Date	14-Apr-11	Job No.	FL1868.04
Attention	Mr. Thomas Lubozynski, P.E.		
Re:	Response to Request for Add'l Information Class I - Lateral Expansion Construction J.E.D. Solid Waste Mgmt. Facility Permit App No. SC49-0199726-017

**Subject: Response to Request for Additional Information dated 18 March 2011
J.E.D. Solid Waste Management Facility (WACS #89544)
Class I – Lateral Expansion Construction
Osceola County, Florida
(Permit Application No. SC49-0199726-017)**

TITLE:				
LEACHATE COLLECTION SYSTEM LAYOUT PLAN I				
PROJECT:				
LATERAL EXPANSION MAJOR SOLID WASTE PERMIT MODIFICATION				
SITE:				
J.E.D. SOLID WASTE MANAGEMENT FACILITY

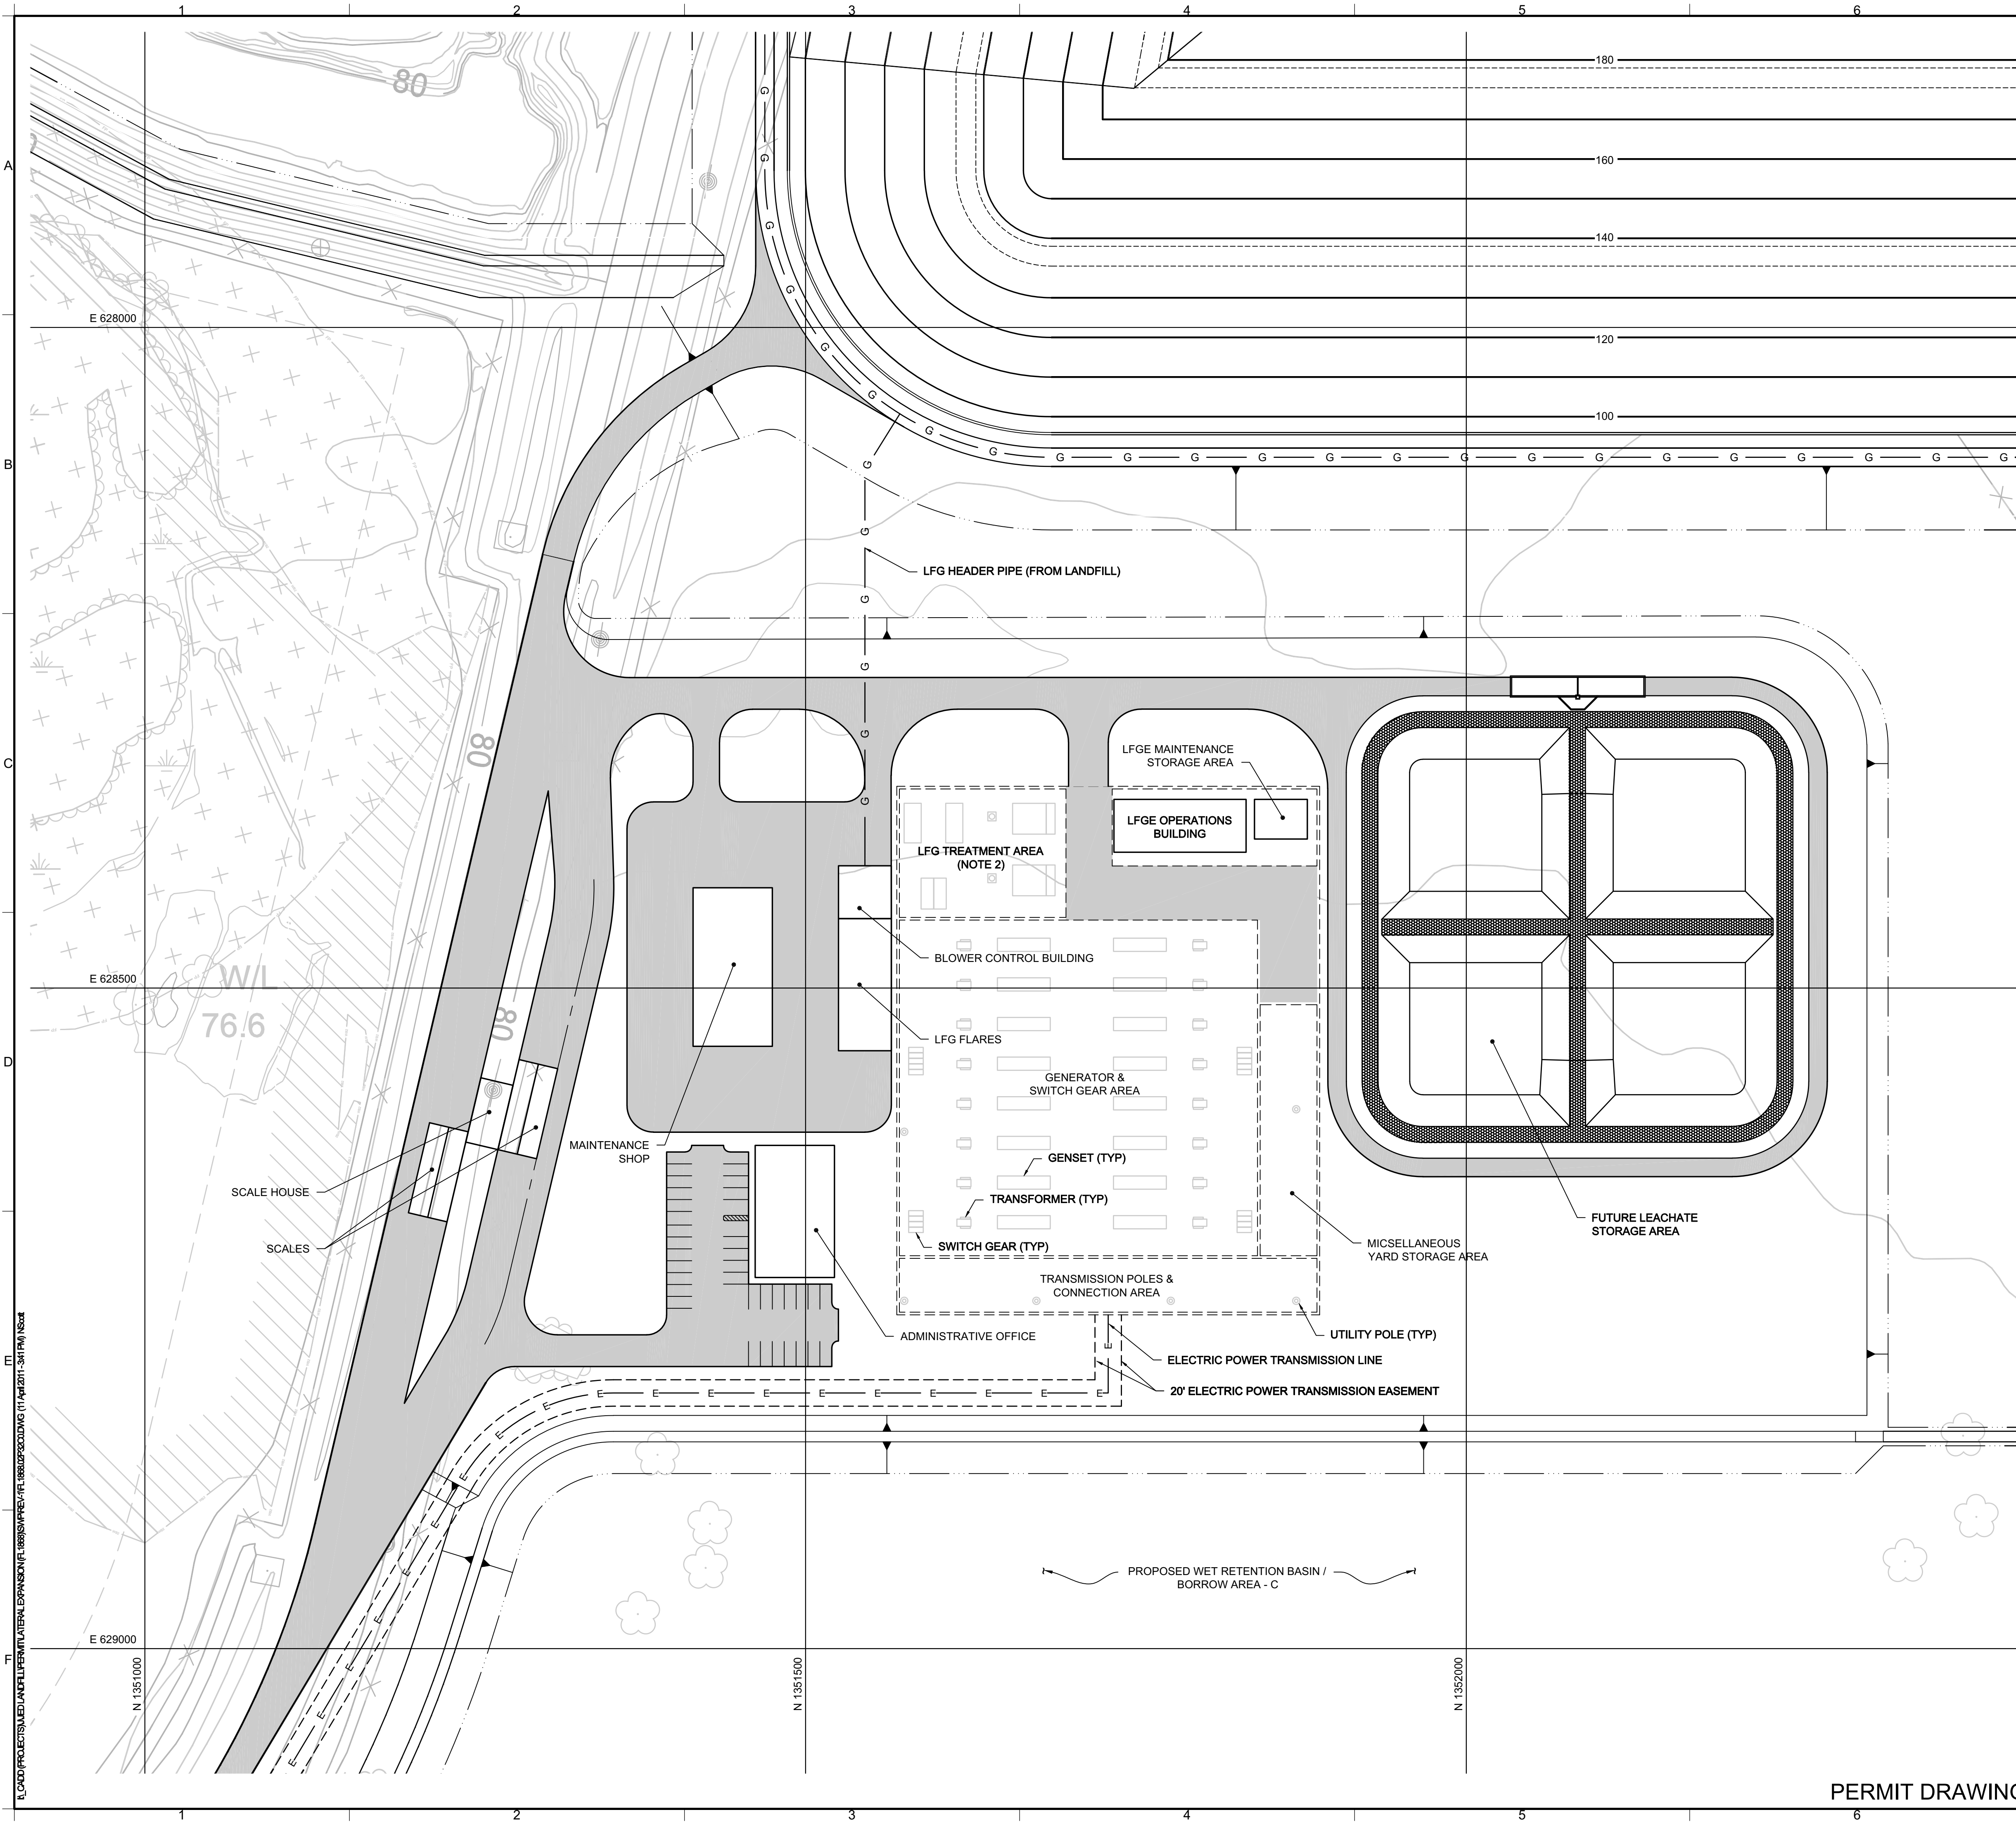
- a. The contours seem to be two feet above the contour elevations in Drawings 9A and 9B. However, according to the legend these are the subbase elevations, just like those depicted on Drawings 9A and 9B.*
- b. The cross section drawing of the liner and leachate collection system (Detail PL on Drawing 18) does not indicate that the leachate collection system will be two feet above the subbase elevation.*
- c. Please clarify.*

Drawings 10 and 11 have been revised to indicate the correct legend text for top of liner protective layer grades. In addition, the details on Drawing 18 have been revised to indicate that the liner protective layer of the leachate collection system will be two feet above the subbase elevation. Revised Drawings 10, 11, and 18 are included in **Attachment 1**.

Figure 3
Locations of Analyzed Settlement Points on Liner Grading Plan
JED Facility, St. Cloud, FL

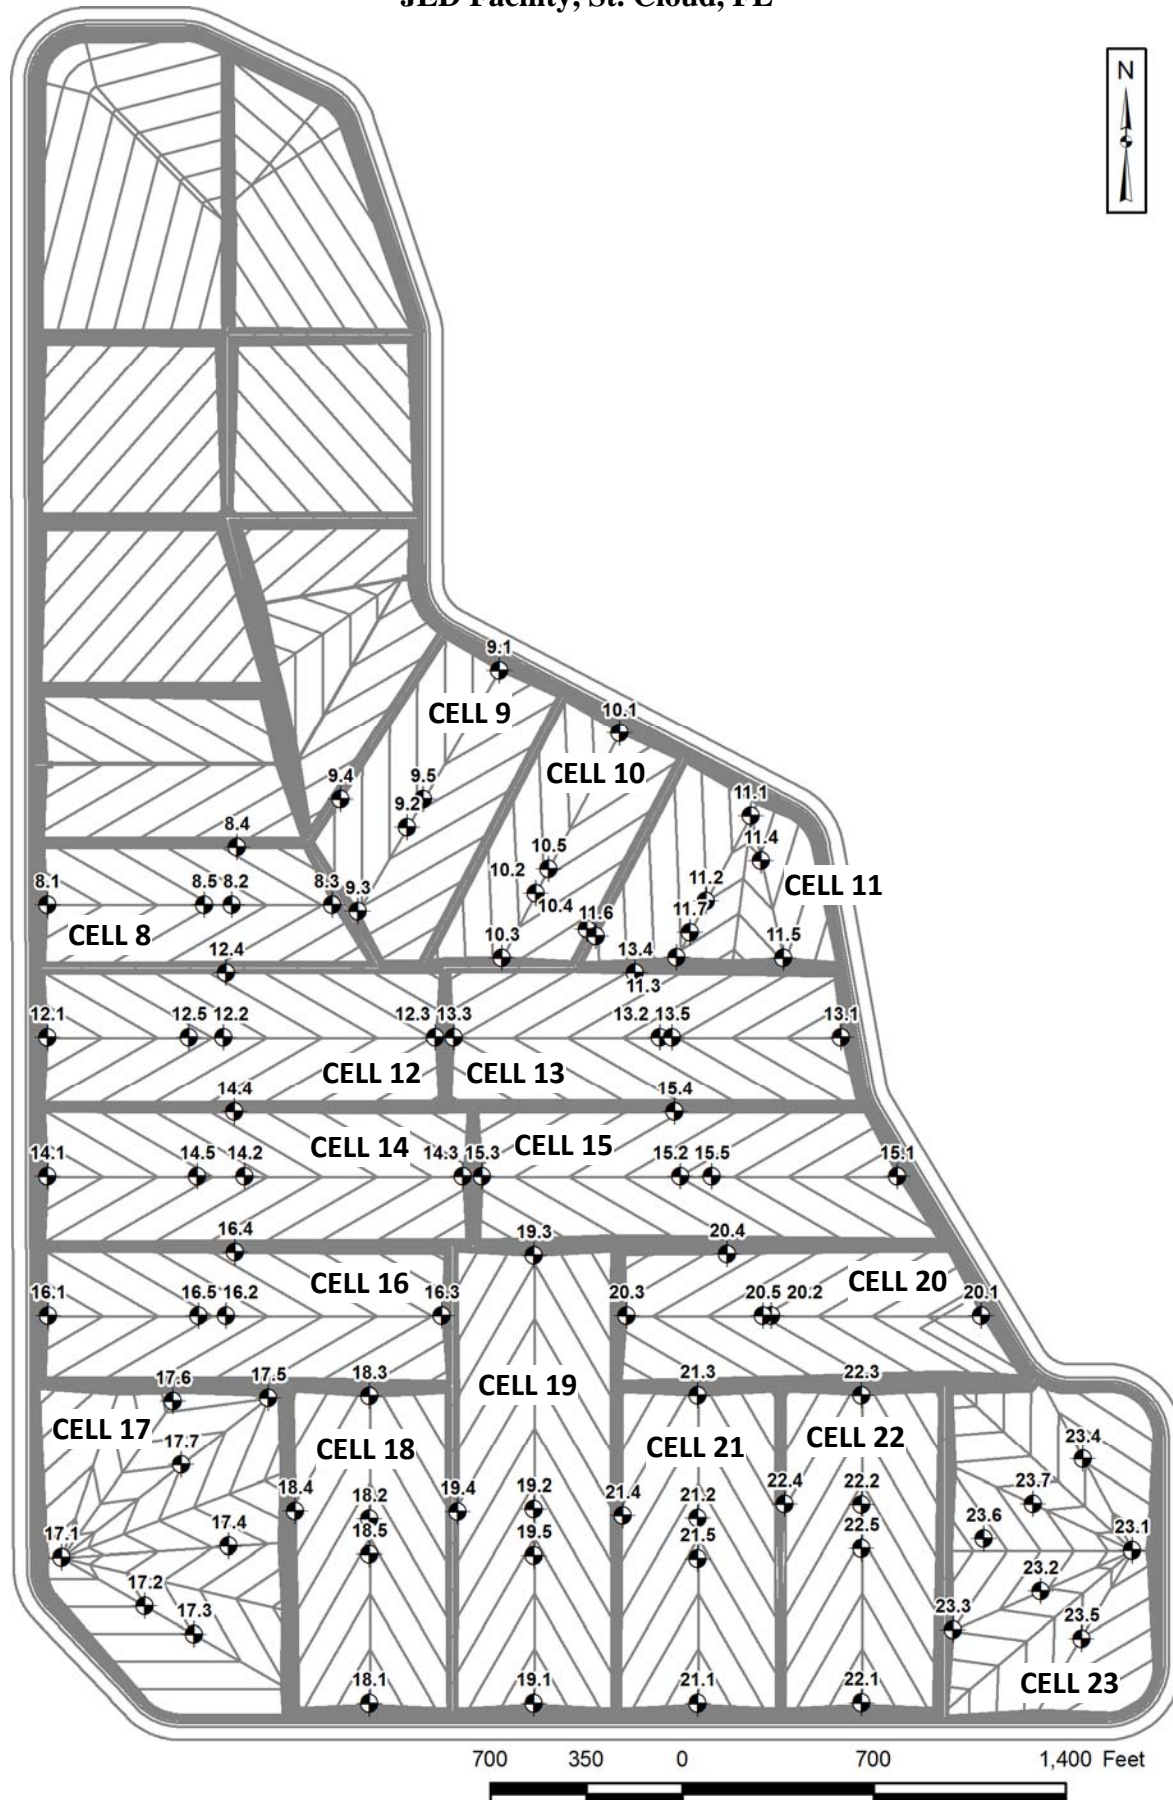
13. Appendix F, Page 8 of 13, Section 7 Results states that inspection of Tables 3 and 4 prove the slope requirements of 0.3 percent and 1.0 percent will be met, post-settlement. We could not find the calculations, data, or summary tables that show those calculations have been accomplished for each cell 11 through 23. Provide a table or other summary of data and results that provide the basis for the conclusions stated in Section 7 (for example, a table with pre- and post-settlement elevations and the resulting calculated slope for each cell).

Table 3 of the Settlement calculations has been revised to include pre- and post-settlement elevations and a note has been added to describe the settlement point ID format to clarify what points correspond to a given Cell. Table 4, which includes the pre- and post-settlement calculated slopes for each cell, has been reformatted to more clearly show that calculations have been provided for each Cell. Figure 3 has also been revised with Cell identification labels to clarify what settlement points correspond to a given Cell. The revised Tables and Figure are provided in **Attachment 6**.
